# Preliminary Design Plans Route 44 Self Storage

5 Unit Self Storage Project  
Assessor's Plat 17 Lot 213  
Putnam Pike (Rte. 44) Gloucester, RI

RIDEM COPY

Site Layout Plan  
**Route 44 Self Storage**  
Putnam Pike (Rte. 44)  
Prepared for:  
**Jay Foige**  
401 Snake Hill Road North Scituate, RI 02857  
date: Feb-2008  
scale: As Noted

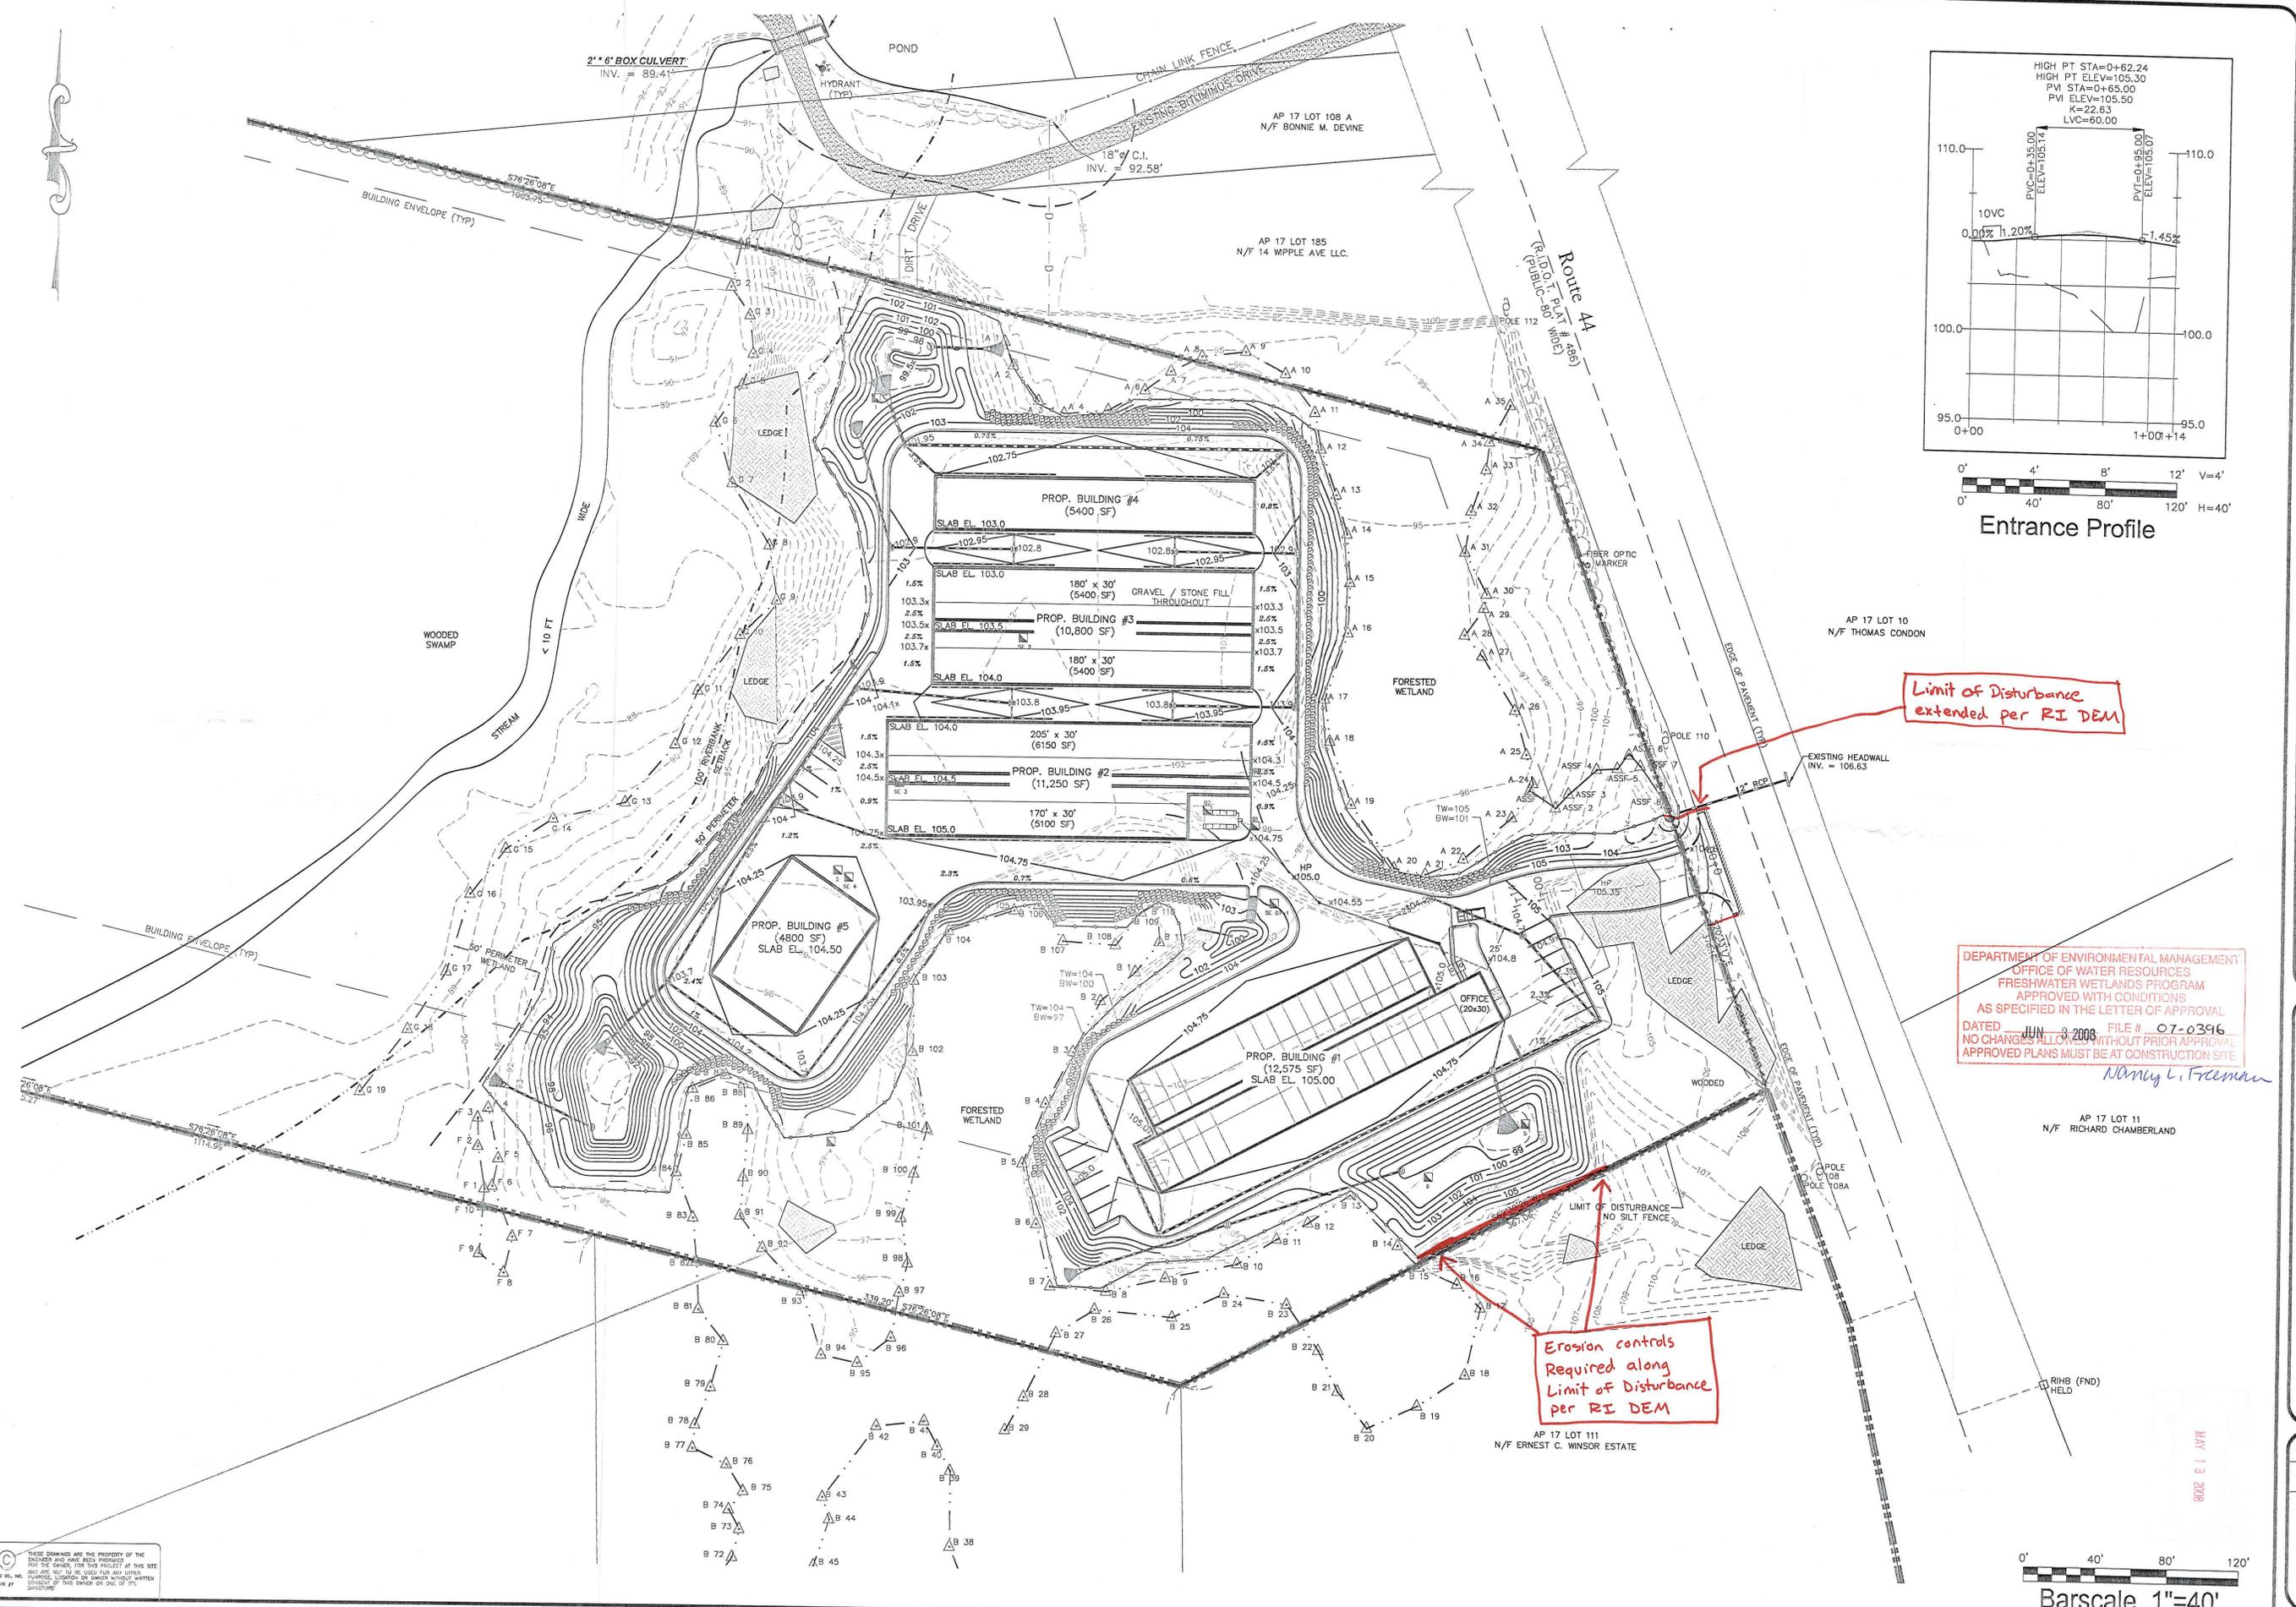
Limit of Disturbance extended per RI DEM

Erosion controls Required along Limit of Disturbance per RI DEM
